LATHAN
ARCHITECTS
LATHAN ■ BRYANT ■ CALMA

ADDENDUM NO. 2
ADDITION AND RENOVATION FOR FLOMATON ELEMENTARY SCHOOL
PACKAGE A: MEDIA CENTER AND CLASSROOM ADDITION
DCM NO. 2021011 PSCA NO. 9167
Architect Job No. 21-04A
March 29, 2022

The Plans and Specifications are hereby amended. The following supersedes all contrary and/or conflicting information and is made part of the contract documents.

1 LIGHTING PLAN
1/8" = 1'-0"

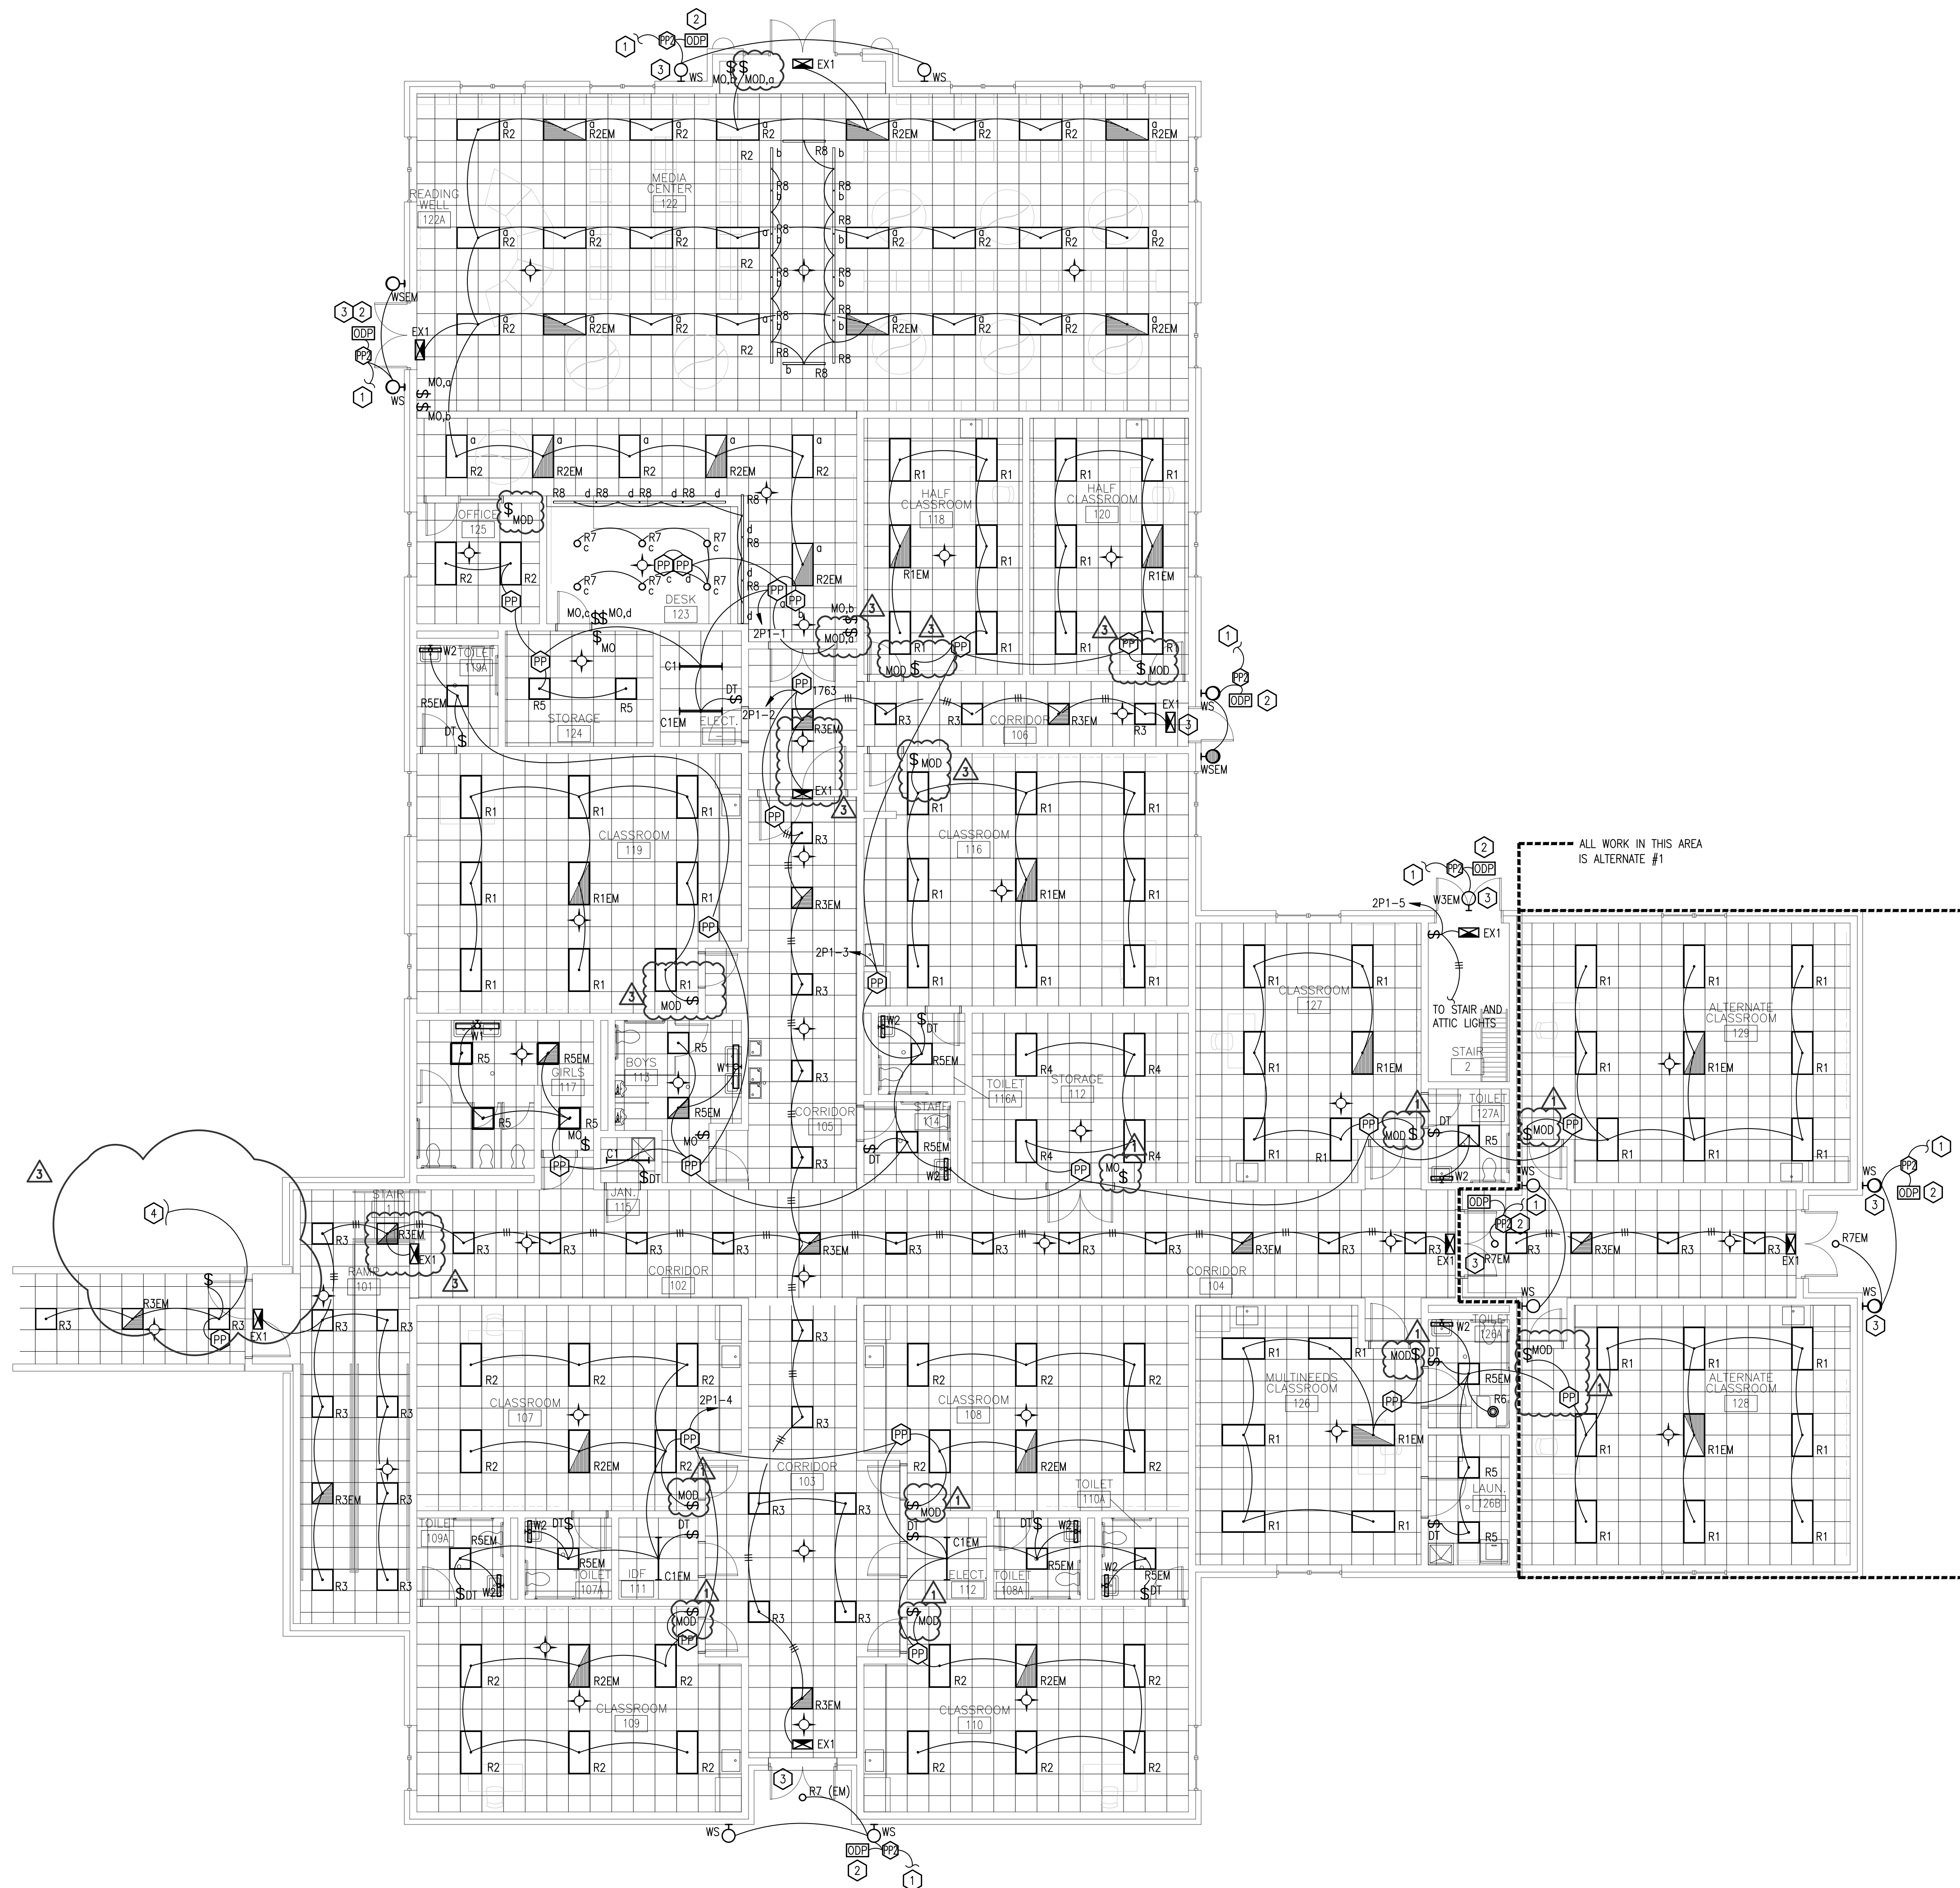
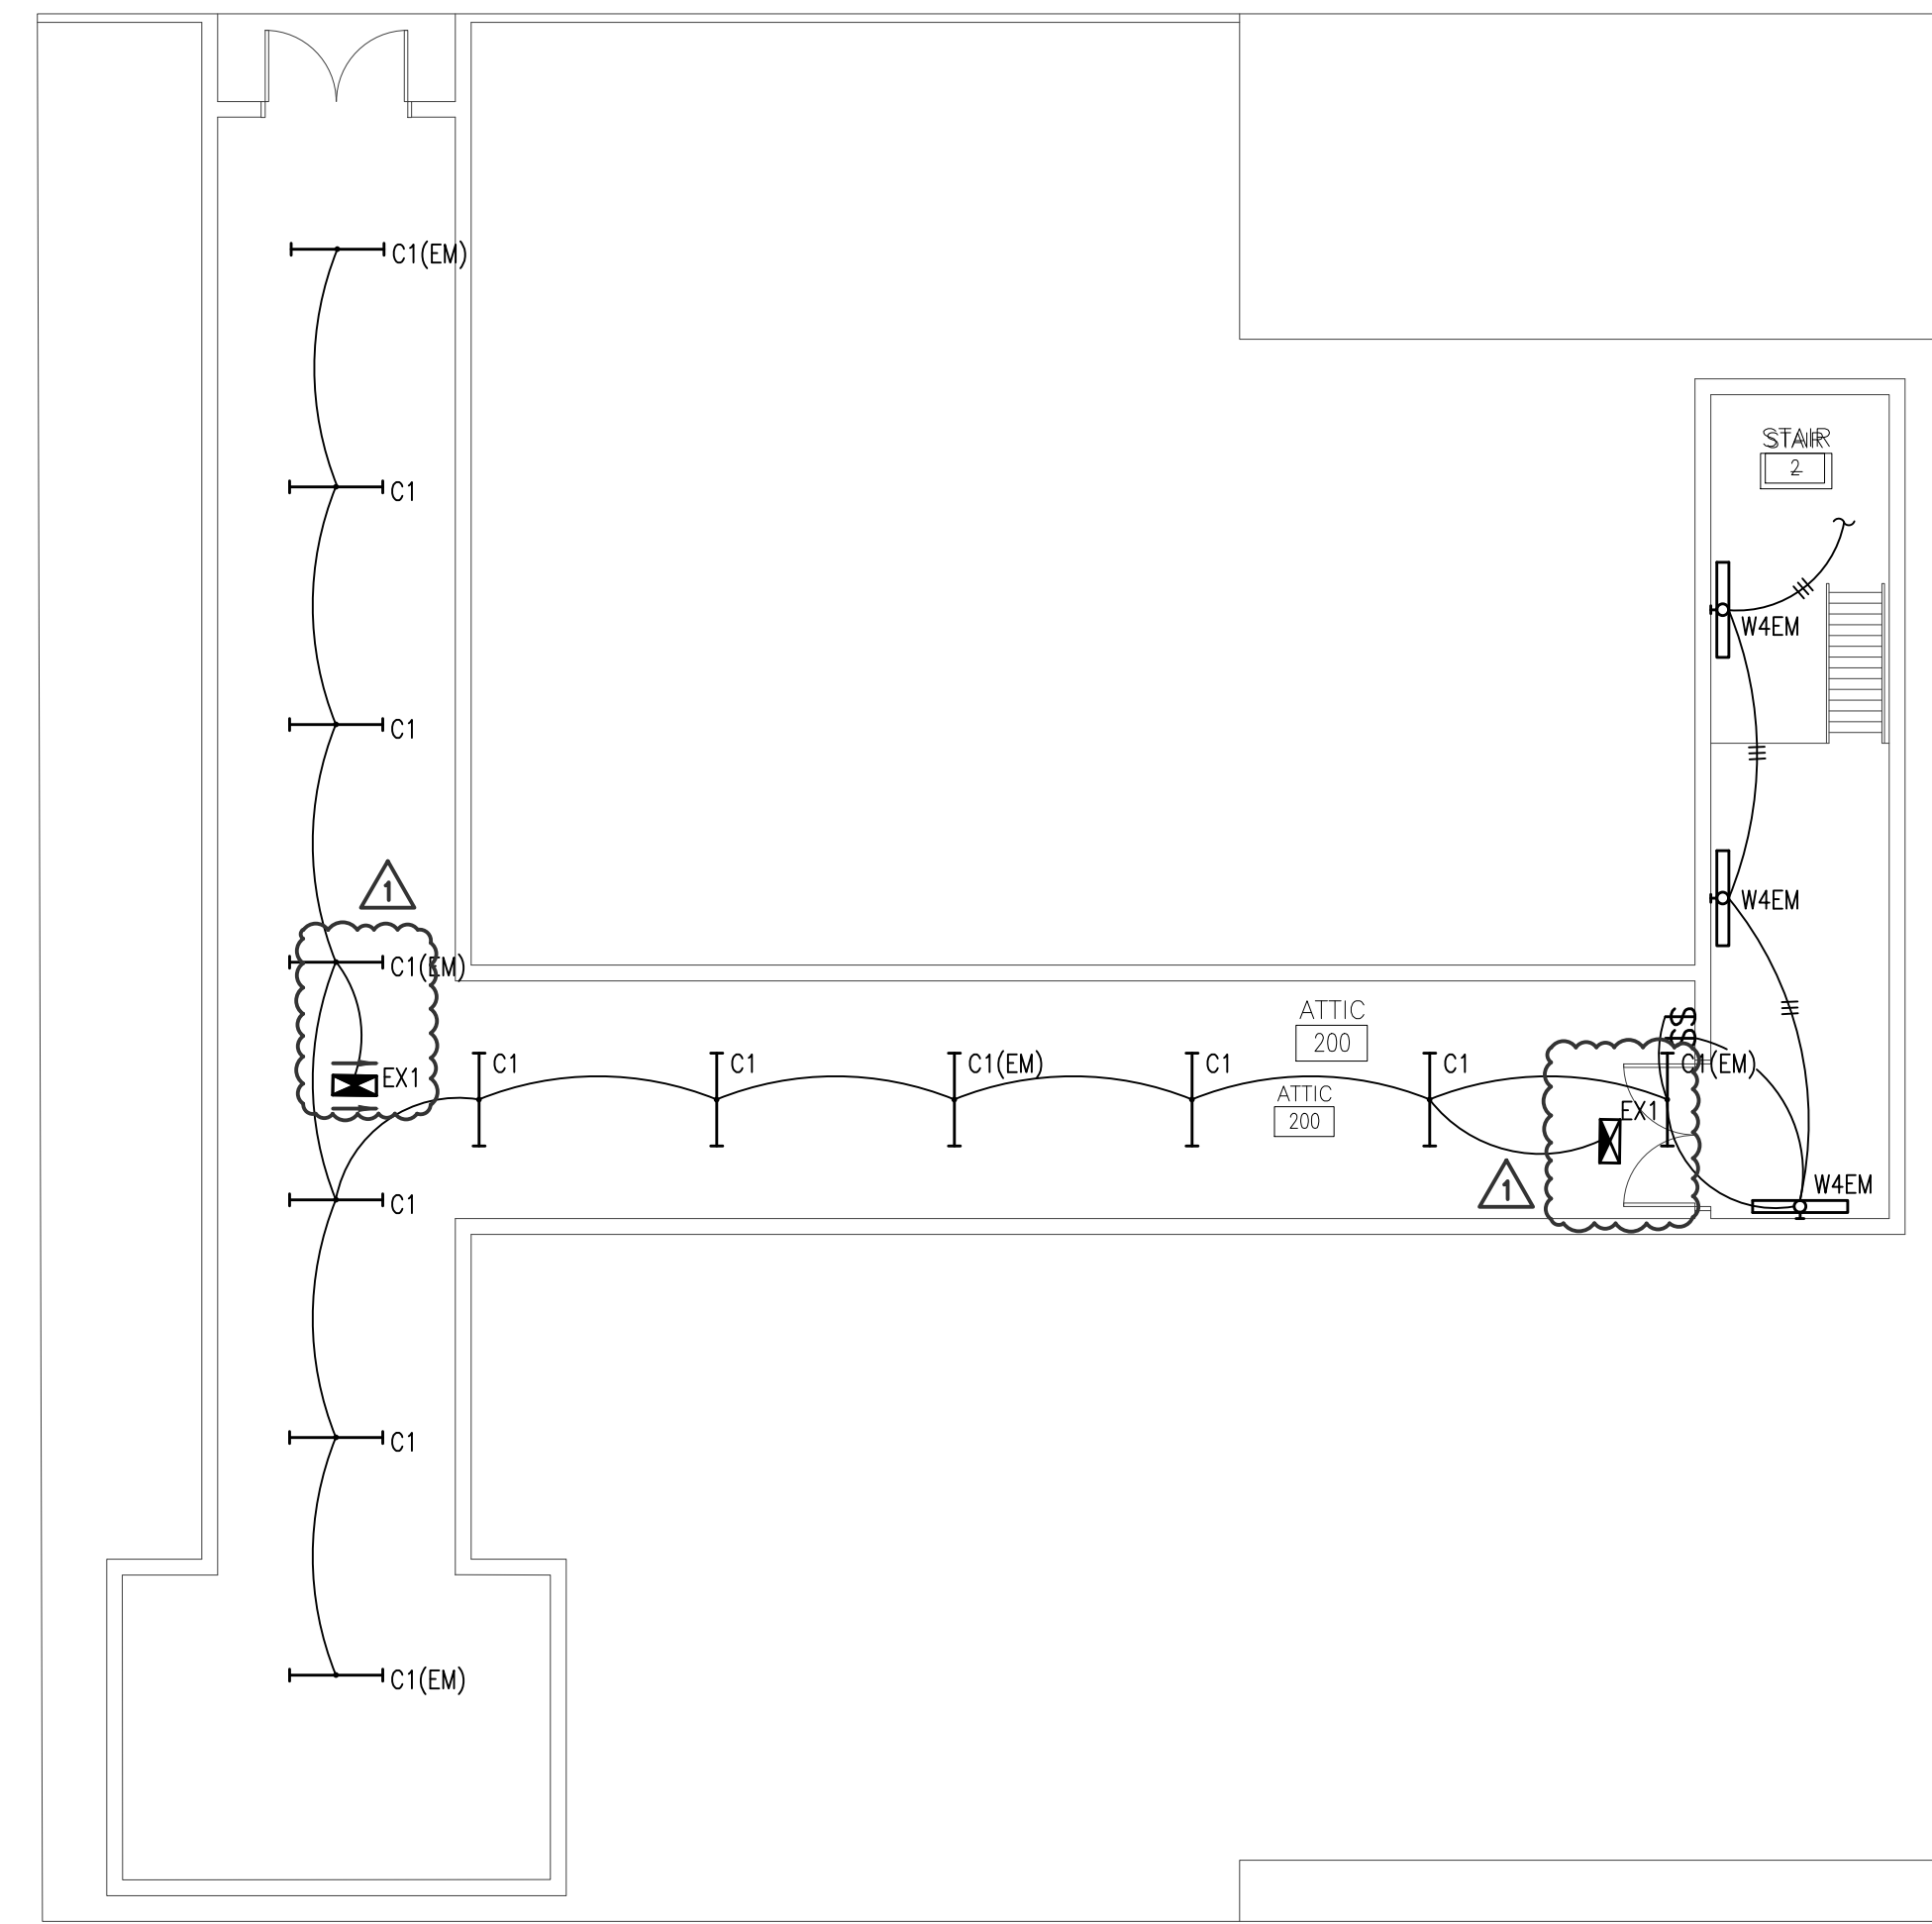
2. E0.1 – Electrical Site Plan - revised electrical site plan.
3. E1.1 – Lighting and Power Plan – Revised sheet to include additional exit signs have been added and the locations have been coordinated with the architect, Circuits have been revised such that they are being fed from the existing building, WSEM has been added to the emergency lighting schedule, and dimmer switches have been added to all offices and classrooms to allow bi-level control.
